Work Order ID 86823

Item Name: Head Rest

DRAWING NO. D3303	TITLE HEAD REST	REV. B	DART AEROSPACE LTD ENGINEERING ORDER		D.E.O. NO. D3303-B-1	SHEET NO. SHEET 1 OF 1	SCALE NTS
DRAWN AJS	CHECKED <i>h</i>	MFG. APPR. <i>h</i>	APPROVED <i>h</i>		DE APPR. <i>h</i>		
DATE 08.10.15	DATE <i>08.10.15</i>	DATE <i>08/10/16</i>	DATE <i>08/10/16</i>		DATE <i>08/10/16</i>

D3303-041 HEAD REST

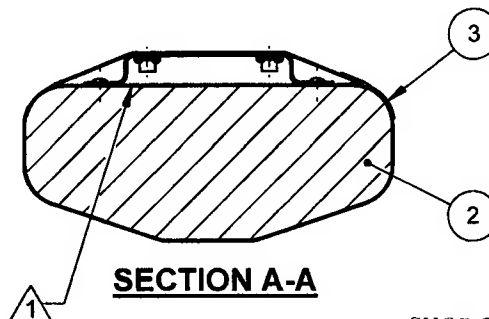
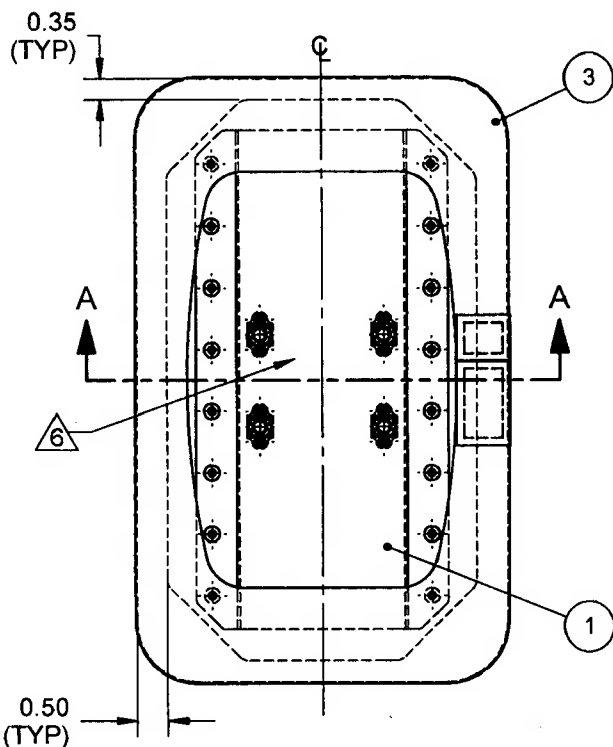
SHEET 1 ADD 1300L ADHESIVE BY 3M TO NOTE 1 AS FOLLOWS:

- 1) BOND D3305-1 FOAM TO D3303-043 BRACKET ASSEMBLY USING 3M 1300 OR 1300L ADHESIVE (0.002" TO 0.010" THICK) IN ACCORDANCE WITH MANUFACTURER'S INSTRUCTIONS
